Access Compliance Report

Public Rights-of-Way

Intersection ID: 27197	Main Street: BALLANTYNE_COMMONS_PY	Cross Street: CRESTWOOD_DR	Location: SW
ADA ID: 4E660514C2EA	Ramp Type: Perp	Initial Pass/Fail: Fail	Overall Compliance: No
Severity Score: 22.5			
Codes/Mitigation Info/Possible Solution		Field Measurements/Component Compliance

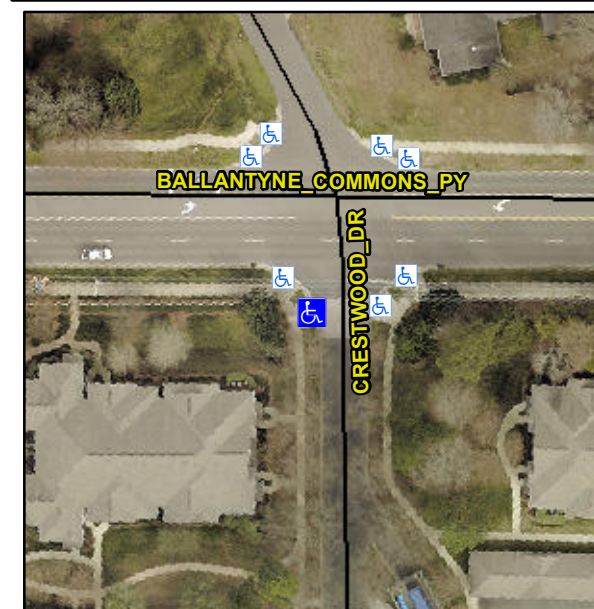
R304.5.1, R304.2.2, R304.5.3

Compliance	Description	Data	Compliance	Description	Data
N/A	Ramp Length (in)	98.0	No	Ramp Slope (%)	8.8
No	Ramp Width (in)	37.0	No	Ramp XSlope (%)	4.2
N/A	Flare Type LT	N/A	N/A	Flare Type RT	N/A
N/A	Flare Slope LT (%)	N/A	N/A	Flare Slope RT (%)	N/A
N/A	Flare Traversable LT?	N/A	N/A	Flare Traversable RT?	N/A
N/A	Landing Length (in)	N/A	N/A	DWS Provided?	N/A
N/A	Landing Width (in)	N/A	N/A	DWS Contrast?	N/A
N/A	Landing Slope (%)	N/A	N/A	DWS Length (in)	N/A
N/A	Landing X Slope (%)	N/A	N/A	DWS Full Width?	N/A
N/A	Landing Curb? (Y/N)	N/A	N/A	DWS Offset (in)	N/A
N/A	Shared Landing?	N/A			
N/A	Gutter Ponding?	N/A	N/A	Gutter Slope (%)	N/A
N/A	Gutter Lip Ht (in)	N/A	N/A	Gutter X Slope (%)	N/A
N/A	Painted X Walk1?	No	N/A	Painted X Walk2?	N/A
	X Walk 1 Direction	To E		X Walk 2 Direction	N/A
N/A	X Walk 1 Width (in)	N/A	N/A	X Walk 2 Width (in)	N/A
	X Walk 1 Slope (%)	0.2		X Walk 2 Slope (%)	N/A
	X Walk 1 X Slope (%)	3.3		X Walk 2 X Slope (%)	N/A

Remove & Replace Entire Ramp.
